CNL-14-010

January 16, 2014

Sequoyah Nuclear Plant, Units 1 and 2
Facility Operating License Nos. DPR-77 and DPR-79
NRC Docket Nos. 50-327 and 50-328

Subject: Response to NRC Request for Additional Information Regarding the Review of the Sequoyah Nuclear Plant, Units 1 and 2, License Renewal Application, 3.0.3-1 (Requests 3b, -3a, 4b, 6b); B.1.34-8; B.1.34-9; A.1-2; Tables 3.3.1, 3.3.2-11, and 3.6.1 (TAC Nos. MF0481 and MF0482)

Figure 1
Lower Radial Support Comparison

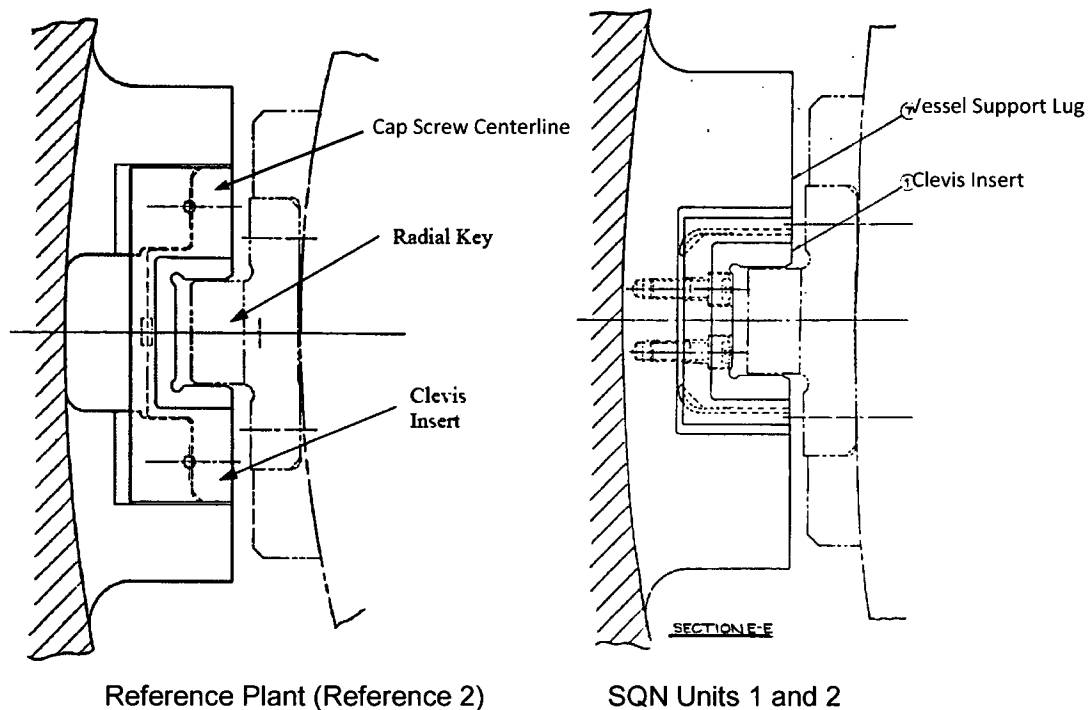
LRA Table 3.1.2-2, *Reactor Vessel Internals*, indicates that the clevis insert bolts are nickel alloy and that cracking will be managed by the Reactor Vessel Internals Program in the “no additional measure” inspection category. Appendix A to *Materials Reliability Program: Pressurized Water Reactor Internals Inspection and Evaluation Guidelines (MRP-227-A)* (Reference 1) indicates that failure of Alloy X-750, precipitation-hardenable nickel-chromium alloy, clevis insert bolts were reported by one Westinghouse designed plant in 2010. Furthermore, the staff noted that these clevis insert bolts failed because of cracking, which is an aging effect that was not addressed in MRP-227-A.

The staff noted that the ASME Code, Section XI specifies a VT-3 visual inspection for the clevis insert bolts, which may not be adequate to detect cracking before bolt failure occurs. In addition, since cracking of the clevis insert bolts was not addressed during the development of MRP-227-A, it is not clear to the staff whether this operating experience is applicable to the applicant and whether the Reactor Vessel Internals Program will need to be modified to account for this operating experience.

1. Specify the fabrication material, including any applicable heat treatment, for the clevis insert bolts at Units 1 and 2.
2. Discuss and justify whether the operating experience associated with cracking of the clevis insert bolts is applicable to Units 1 and 2.
 - a. If applicable, discuss and justify how the Reactor Vessel Internals Program will be augmented to require an inspection of the clevis insert bolts capable of detecting cracking. If the Reactor Vessel Internals Program will not be augmented, provide a technical justification for the adequacy of the existing VT-3 visual inspection to detect cracking before it results in clevis insert bolt failure.

The following response provides the technical justification for the adequacy of the existing inspection requirement to manage the effects of possible cracking of lower radial support clevis insert bolts (cap screws).

This material and heat treatment is the same as used for the clevis insert cap screws at the reference plant where cracking has been observed (Reference 2). The cap screws are of the same design, except that the SQN cap screw shank length is [] longer. The cap screws were installed with the same torque as that used for the reference plant.

Because the clevis insert cap screws for the SQN units are of the same design (except for the [] longer shank), of the same material, torqued to the same degree, and operated at close to or slightly hotter T_{cold} inlet temperatures as compared to the reference plant, it is possible that these cap screws can eventually crack in a manner similar to that of the reference plant in Reference 2. Therefore, the operating experience discussed above is applicable to SQN Units 1 and 2. A recent draft report summarizing metallurgical investigations of the degraded cap screws from the reference plant provided preliminary confirmation that primary water stress corrosion cracking (PWSCC) was the failure mechanism.

The clevis insert, if completely loose to slide radially inward, is captured in a manner similar to the reference plant and is restrained by a similar radial gap before it contacts the radial key. This condition would require the two interference-fit dowel pins to also lose restraint. With the clevis insert displaced

If all of the cap screws are broken, and no restraint by the dowel pins is assumed, the clevis insert can still resist sliding. During normal hot operation, the insert maintains preload over the range of initial shrink-fit interference applied to the insert. As a result, the frictional resistance of the insert against the support lug is always greater than the applied frictional radial loads acting on the insert from the key. These hot preload forces are greater than the forces in the range calculated for the reference plant, and so have greater resistance to loosening and sliding. Therefore, although long-term loosening and wear, which would be expected to occur over more than a few cycles, cannot be ruled out, the clevis insert design installed at SQN Units 1 and 2 provides improved resistance to such long-term effects relative to the reference plant. Operating experience with damaged bolts and one dowel pin, as described in Reference 2, showed no discernible change in the clevis insert wear surfaces after operation for two additional cycles. It is fully expected that with the design installed at SQN Units 1 and 2, longer operation can be maintained before discernable degradation occurs. In addition, the insert has a thick upper flange that prevents it from falling downward, and the downward force from the downcomer flow will prevent it from working upward.
